Re: Valero Benicia Crude by Rail Project Final Environmental Impact Report

The City of Davis (“Davis”) submits the following comments on the Final Environmental Impact Report (FEIR) for the Valero Benicia Crude by Rail Project.

Figure F2a: Average track segment fuel efficiency for UPRR in California
 (from: Gould & Niemeier, supporting documentation)

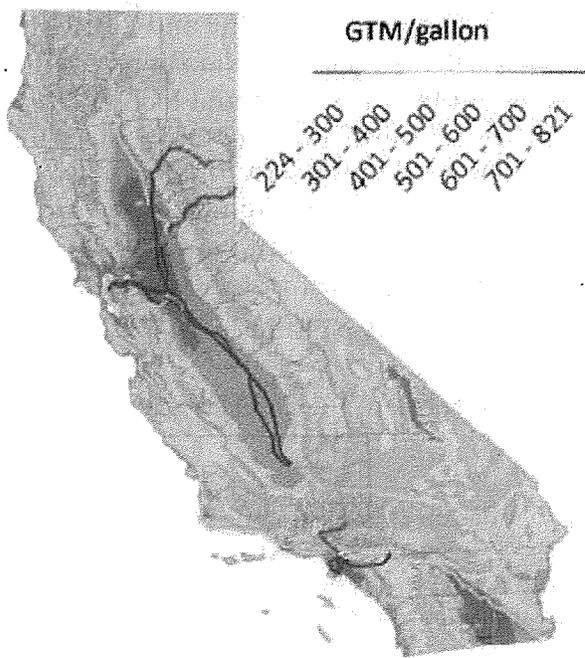
Figure F2a illustrates the average fuel efficiency in California for various track segments determined by the UC Davis study based on data provided by UPRR.¹²² Figure F2b shows the likely routes crude oil deliveries to Benicia would take through northern California according to the EIR.

with the lowest average track segment fuel efficiency within the state (see Figure F2a red: 224-300 GTM/gal). The route from Oregon to Roseville, identified in red in Figure F2b, also contains a segment with very low fuel efficiency (see Figure F2a orange: 301-400 GTM/gal) and a long stretch with only average fuel efficiency (see Figure F2a turquoise: 501-600 GTM/gal). The route from the Roseville Railyard to the Refinery, identified in Figure F2b in green, is more fuel-efficient due to its relatively flat terrain (see Figure F2a medium blue: 601-700 GTM/gal).

It is important to note that the fuel efficiencies in Figure F2a represent average values across all types of trains (bulk, manifest, intermodal, etc.) operated by UPRR. The UC Davis study also determined a range of fuel efficiencies for bulk trains of 239 to 1536 GTM/gal for the range of track grades and train types observed in California; the *average* fuel efficiency for bulk trains carrying all kinds of freight on *level* tracks in California was estimated at 1061 GTM/gal.¹²³ These values include the weight of the locomotives. Based on traffic density data (in GTM) reported by BNSF and UPRR, the ratio of the fuel consumption index without locomotives *versus* with locomotives can be estimated at 0.92;¹²⁴ the corresponding fuel consumption index without locomotives can be estimated at 976 GTM/gal.¹²⁵ Higher weight and/or hillier terrain lower the average fuel efficiency. Thus, the system-wide fuel efficiency used by the EIR to determine emissions in California — 1005 GTM/gal for UPRR — is much too high because crude oil is among the heaviest freight transported *and* the Project trains would not travel on flat terrain along their entire routes to the California state border but instead, as illustrated in Figures F2a and F2b, would require travel over very steep grades.

Figure F2b: Project rail routes through Northern California
 (from RDEIR, Figure 1-3)

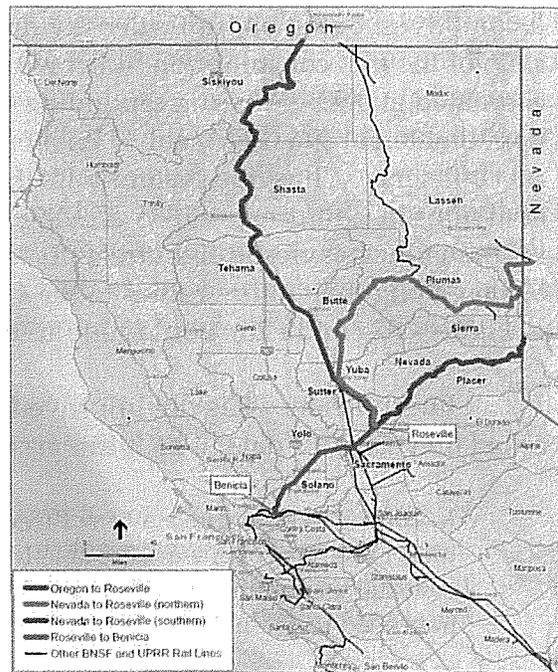
Two of the uprail routes identified as the most likely for delivery of crude oils to the Roseville Railyard in Figure F2b — Nevada to Roseville (northern), identified in blue, and Nevada to Roseville (southern) identified in purple — include long stretches

Figure 3: 2013 area designations for State ambient air quality standards for ozone
 (from: http://www.arb.ca.gov/design/adm/2013/state_o3.pdf (Exhibit 31))

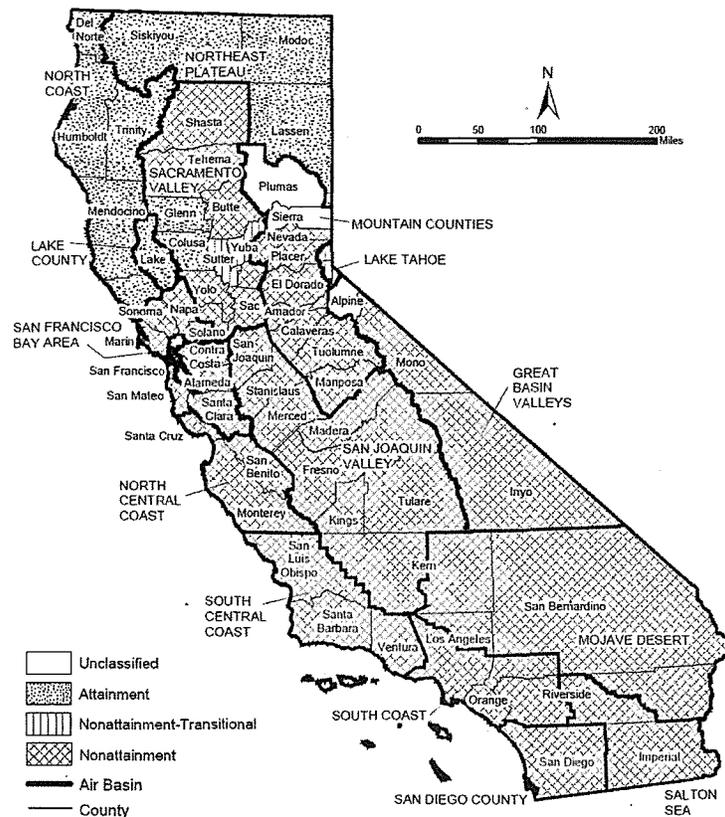
Most of the affected airsheds currently violate California’s 8-hour ozone ambient air quality standard as shown in Figure 3 (nonattainment areas are crosshatched).

Figure F3: Location of MEIW identified by Nossaman Letter and location of highest cancer risk

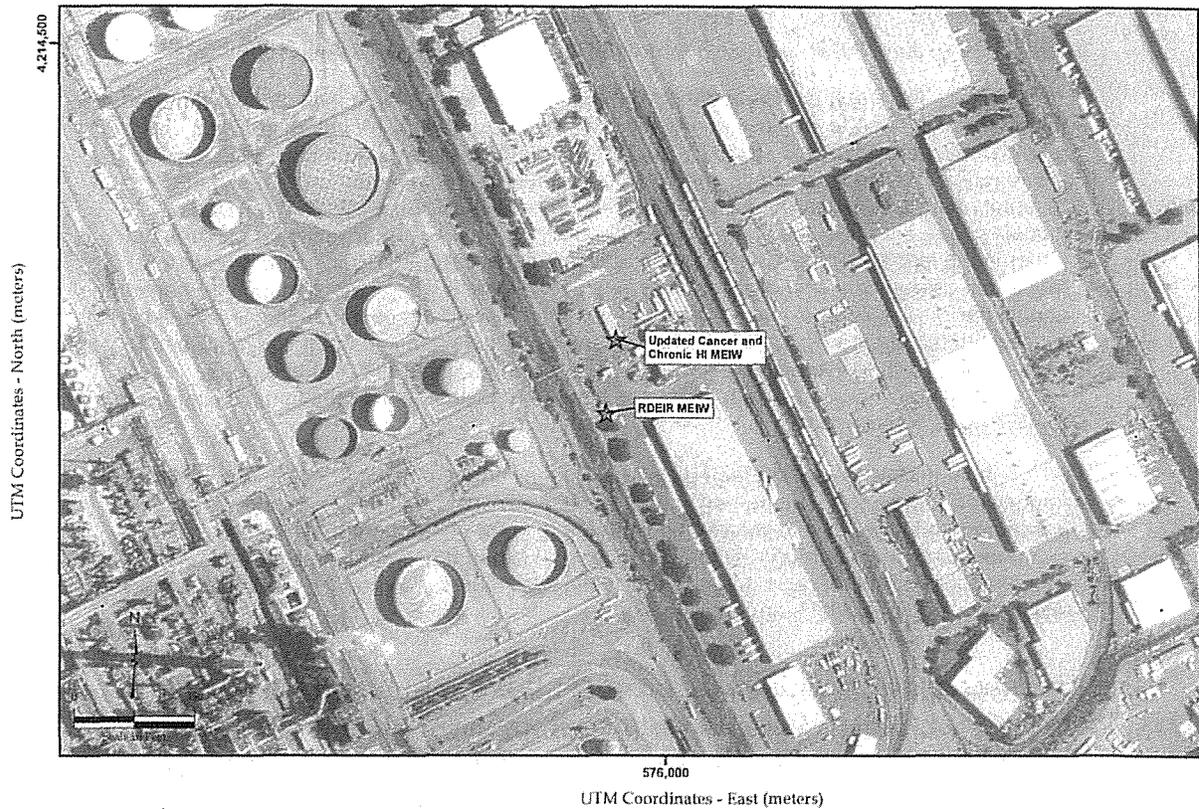
I verified the updated location for the MEIW (NAD27, Zone 10, UTM 576044E, 4214245N) identified by the Nossaman Letter Table 1 (Updated Cancer and Chronic HI MEIW). I also identified the location of the highest locomotive idling emissions and highest cancer risk (NAD27, Zone 10, UTM 576043.6E, 4214194.5N) taking into account the same identified baseline map shift. The two locations, determined with the AERMOD output file provided with the Nossaman Letter, are about 150 feet apart, are shown in Figure F3. The previously identified location with the highest cancer risk (NAD27, Zone 10, UTM 576043.6E, 4214194.5N) coincides with the location of the RDEIR MEIW.

Second, the Nossaman Letter neither addresses nor disputes the considerably higher dispersion factor for locomotive idling and associated significant cancer risk I identified in the Applicant’s modeling files (*see* Figure F3: NAD27, Zone 10, UTM 576043.6E, 4214194.5N), but instead sidesteps this finding, claiming that it is “not
